APPROVED
Plan Review

PROJECT DESCRIPTION:
NEW CUSTOM RESIDENCE

LINDSEY RESIDENCE
17541 ABERT RIDGE VIEW
EL PASO COUNTY, CO 80908

SITE PLAN

2 SITE PLAN
1" = 30'-0"

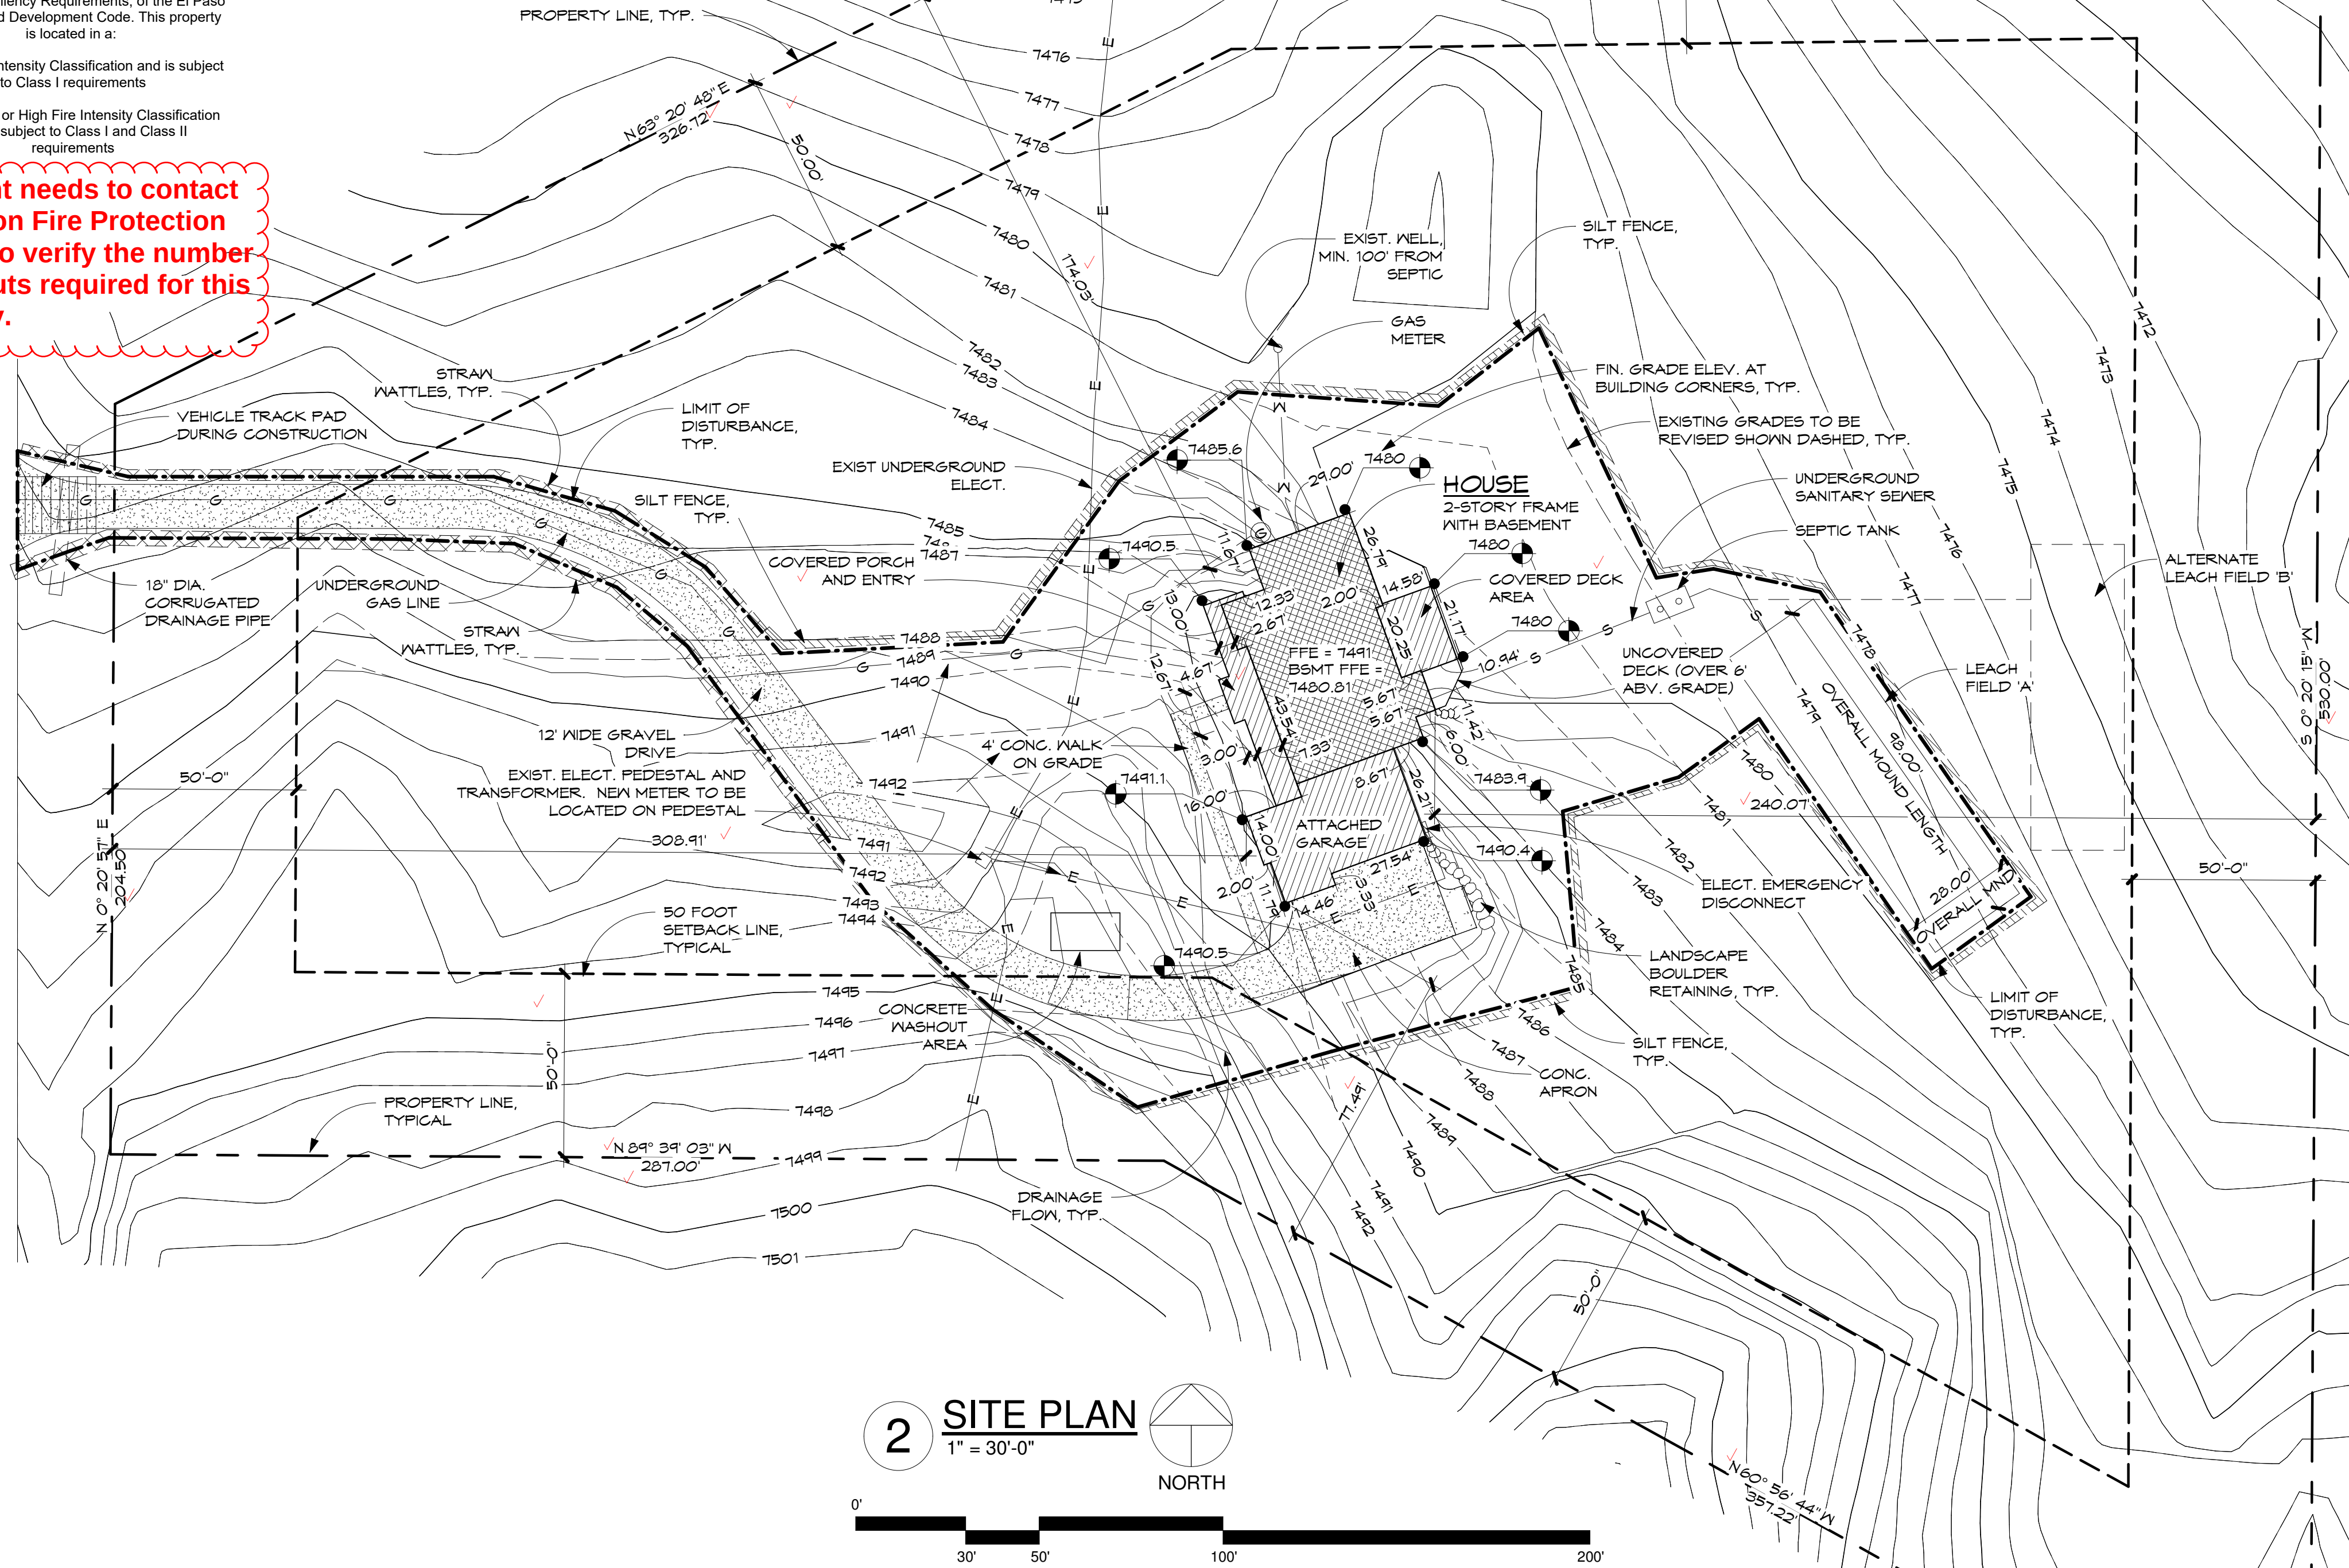
Applicant needs to contact the Falcon Fire Protection District to verify the number of turnouts required for this driveway.
